City of Biddeford Planning Board

August 6, 2025 at 6:00 PM
City Hall Council Chambers & Zoom

- 7.c 2024.34 Final review of site plan application and shoreland permits for a proposed research pier and floats at 11 Hills Beach Road for the University of New England. The project is located in the city Institutional (IN) zone and the Limited Residential District shoreland zone.

PLANNING BOARD STAFF REPORT

**ACCESS ROAD
PLAN AND PROFILE
STA 1+00 TO 4+00**

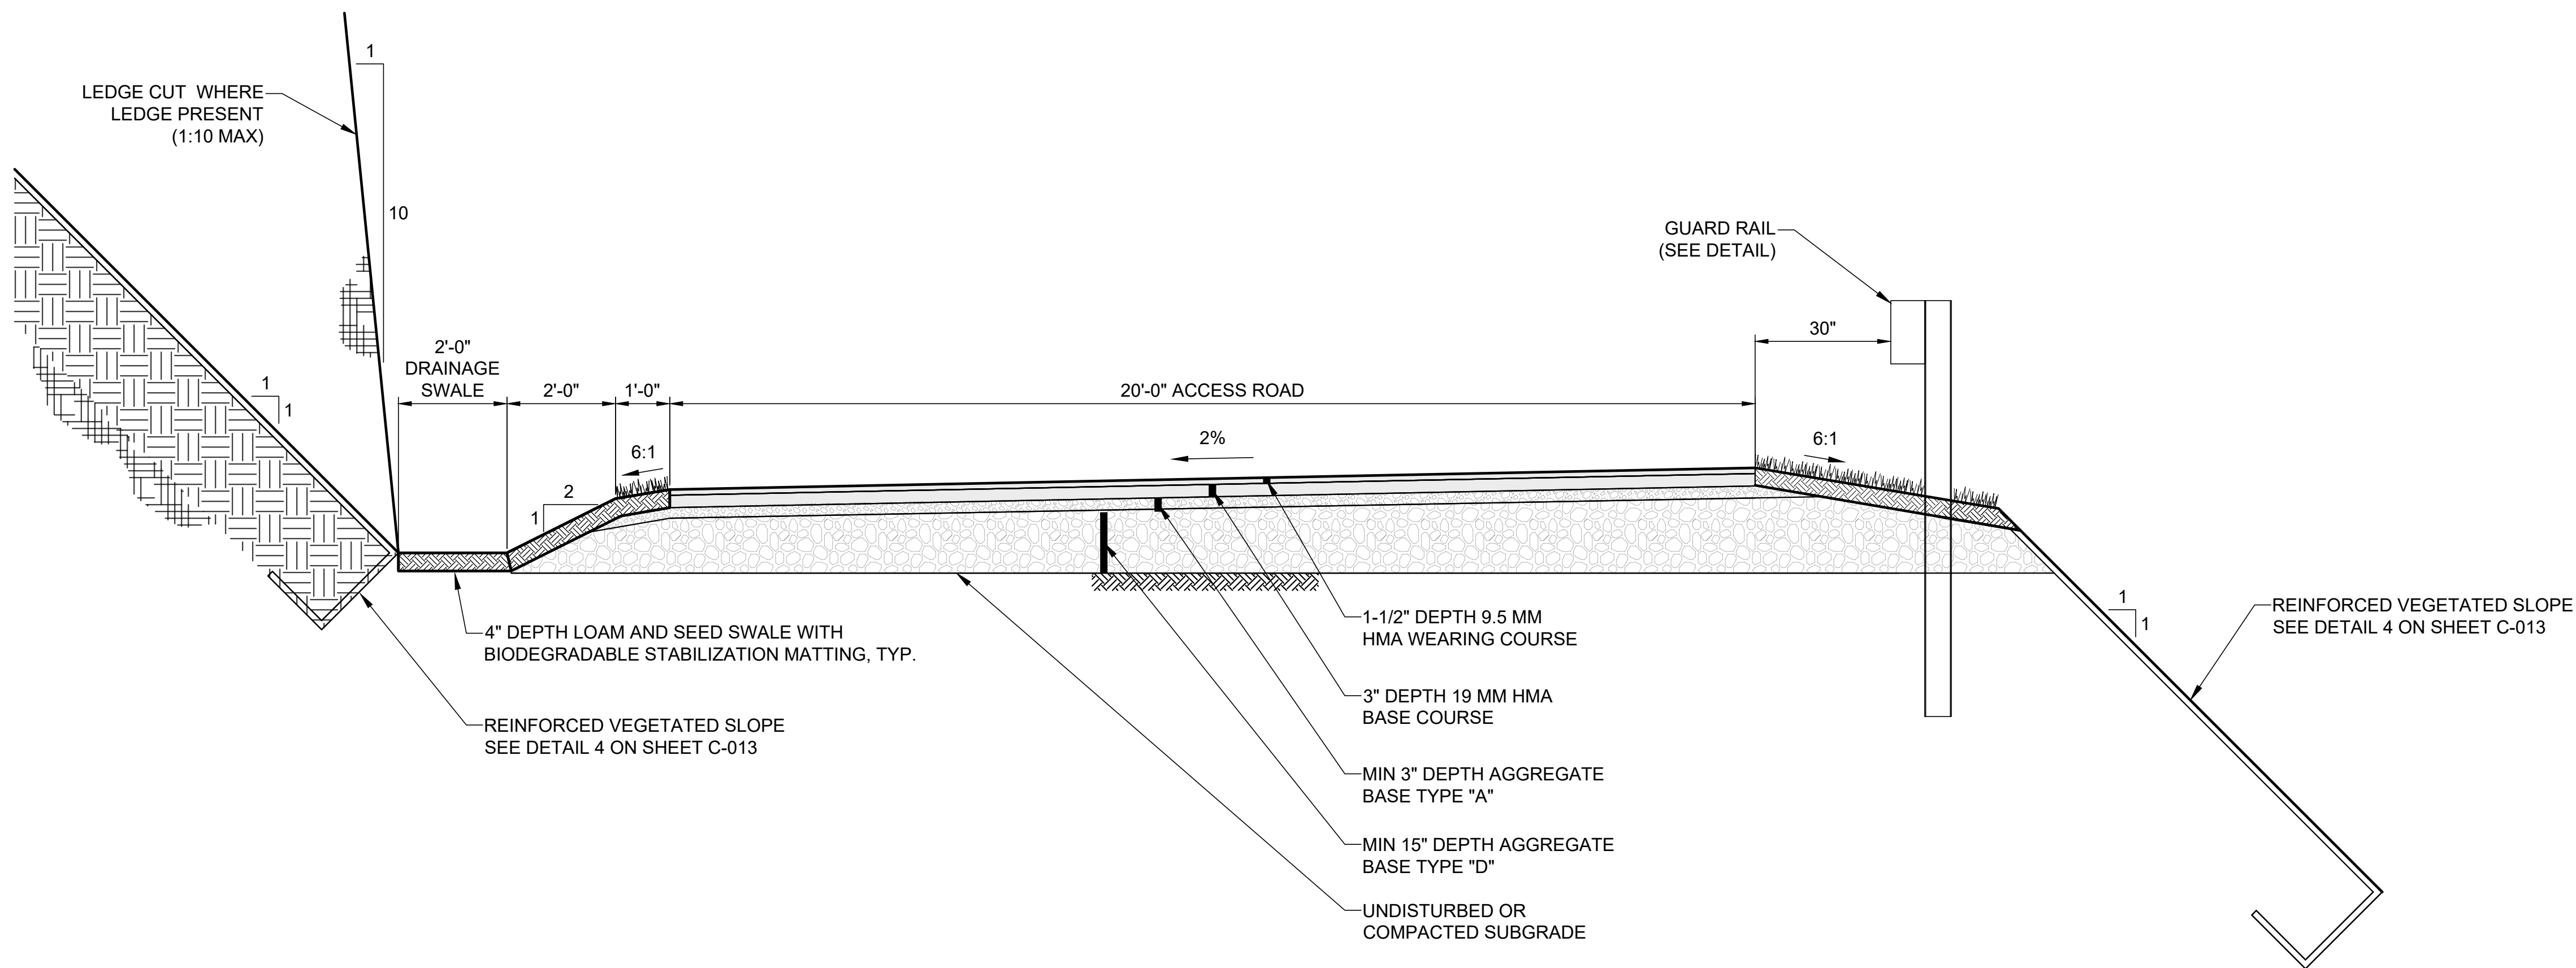
Typical Section provided on sheet C-008 shows the 1:1 embankment starting behind the proposed guardrail. However, Plan View (C-006/007) shows the 1:1 embankment starting in front of the guardrail. The typical section and

We have revised the viewports in Sheets C-006 and C-007 to properly show storm drain pipes in the access road profiles.
